Ref.: C/WWG/P/2425
Your Ref.:
Date: 16/10/2025
Author: C Herbert
Tel: 01267 233833
E-mail: cherbert@francissant.com

RE No 1 Ponderosa Church Street
Flood Consequence Assessment

With reference to NRW's letter (ref: CAS-285580-K9Q4) to Neath Port Talbot Council Planning Department, dated 29th August 2025, I think it is only right and fair to provide the following comments regarding observations made under Flood Risk:

Figure 1 – Lidar Data

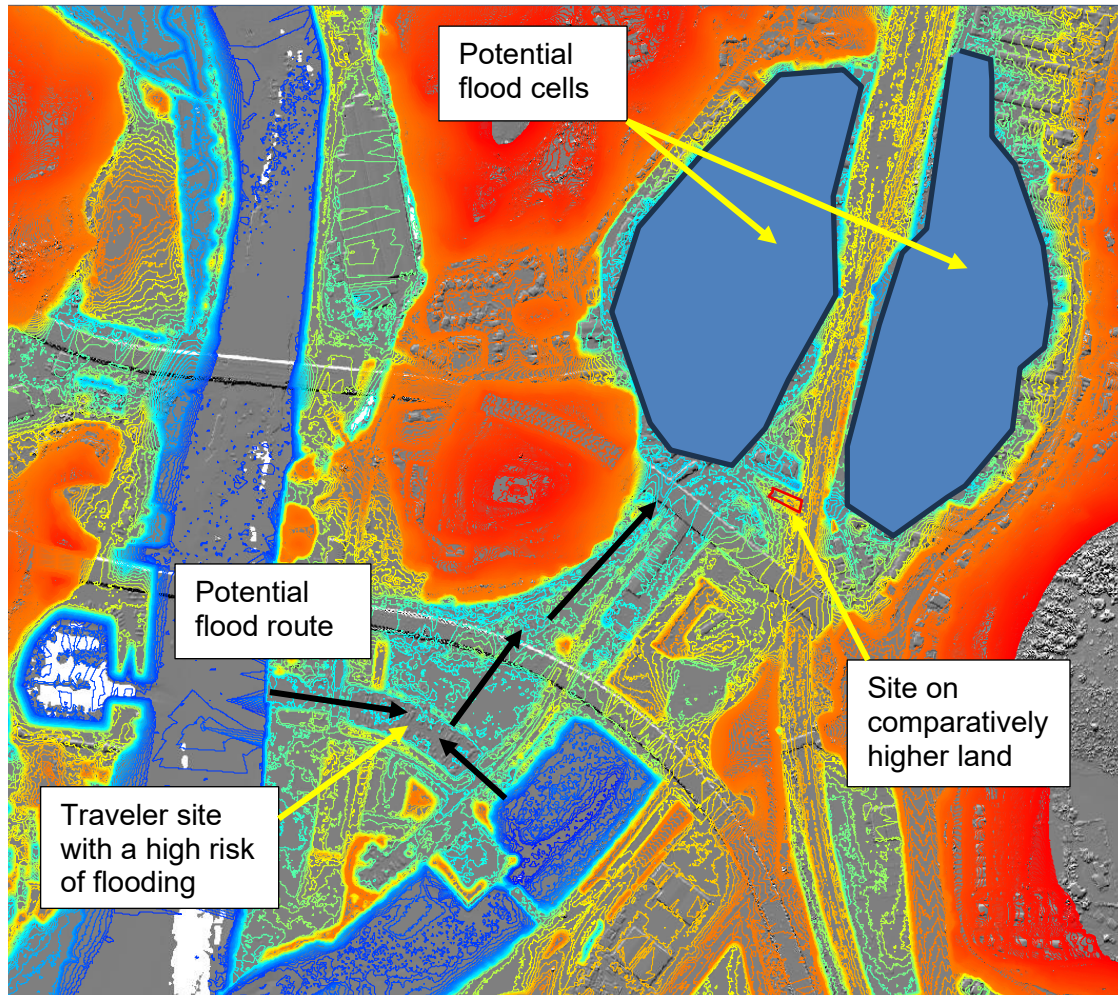
Flooding is likely to occur from the tidal river Nedd via a harbour and the surrounding land. Inspection of the Lidar for the area (see Figure 1) data shows that up to the site the land is comparatively flat with the terrain rising to the site. To the north the land dips to a bowl while the railway line to the east also provides a barrier to the free flow of water. Arguably the lower land to the north along with the area east of the railway lines could be considered as closed flood cells. The site, however, is on the edge of the flood plain directly influenced by the open sea levels. The loss of storage volume, from rising the site levels, will correspond with the reduced volume of water flowing from the ocean with no flood risk impact to third parties. It is also considered that, in this instance, infilling within the considered cells, to the north and east, is also unlikely to have a significant impact on the risk of flooding elsewhere.
